# UNITED STATES PATENT AND TRADEMARK OFFICE

APPLICATION NO.	FILING DATE	FIRST NAMED INVENTOR	ATTORNEY DOCKET NO.	CONFIRMATION NO.
10/622,084	07/16/2003	Trudo Clarysse	IMEC281.001AUS	1852
20995	7590	07/13/2005	EXAMINER	
KNOBBE MARTENS OLSON & BEAR LLP 2040 MAIN STREET FOURTEENTH FLOOR IRVINE, CA 92614			NGUYEN, SANG H	
			ART UNIT	PAPER NUMBER
			2877

**Office Action Summary**

**DETAILED ACTION*****Election/Restrictions***

FIG. 8

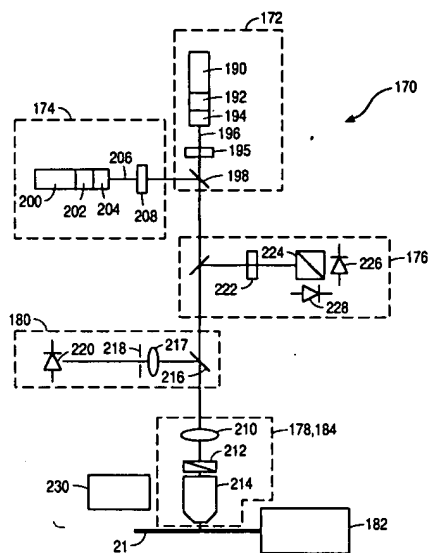
**Regarding claims 1 and 26;** Borden discloses an apparatus and a method for measuring a value of a bulk property of a semiconductor substrate, comprising:

means for (174 of figure 8) providing a generation beam (206 of figure 8);  
means for (172 of figure 8) providing an analyzer beam (196 of figure 8);  
means for (178 of figure 8) focusing the generation beam (206 of figure 8) and the analyzer beam (196 of figure 8) on the semiconductor substrate (21 of figure 6), wherein the generation beam (206 of figure 8) of the generation beam system (174 of figure 8) for generating in an area (22, 24 of figure 2) of the semiconductor substrate (21 of figures 2 and 8) contacted by the generation beam a number of excess charge carriers or electrons (col.4 lines 10-67 and col.6 lines 50-67 and col.8 lines 25-65), having a depth profile (col.8 line 61 and col.13 lines 8-12), the generated excess charge carriers reflecting the analyzer beam (figures 7-8);

means for (176 of figure 8) detecting a predetermined characteristic of the reflected analyzer beam (196 of figure 8; col.13 lines 1-15 and col.14 lines 3-20),

the predetermined characteristic (abstract and claim 1) comprising a near-surface contribution (col.14 lines 45-48) relating to a polarizer or analyzer component of the analyzer beam (114 of figure 6 and 196 of figure 8) reflected near the surface of the semiconductor substrate (21 of figure 6 and 9); and

means for (254 of figure 9) determining the value of the bulk property from the predetermined characteristic of the reflected analyzer beam(252 of figure 9), the bulk property relating to a component (col.14 lines 45-48) of the analyzer beam (114 of figure 6 and 196 of figure 8) reflected in an excess carrier profile region away from the surface of the semiconductor substrate (21 of figure 8 and col.14 line 42 to col.16 line 7), wherein at least the near-surface contribution is eliminated or filtering out from the predetermined characteristic by a filter (222 of figure 8 and 148 of figure 6) . see figures 1-13.

**Regarding claim 2;** Borden teaches about focusing another analyzer beam considered to be a reference beam from analyzer beam generator (172 of figures 7-8) on the area of the semiconductor substrate (21 of figures 7-8) wherein the generated excess charge carriers reflect the another analyzer beam (figures 7-8), and detecting a predetermined characteristic of the reflected another analyzer beam by detector (176 of figures 7-8) , wherein the eliminating of the filter (222 of figure 8) comprises combining the reflected analyzer beam and the reflected another analyzer beam (figures 7-8)..

**Regarding claim 6;** Borden discloses all of features of claimed invention as indicate that splitters (198 of figure 8) splitting the analyzer beam into a reference beam (55 of figures 2 and 7) having the same wavelength as that of the analyzer beam; a polarization beam splitter (224 of figure 8) for creating a difference in phase of about one-eighth and combining the reference beam and the reflected analyzer beam(col.14 lines 5-14).
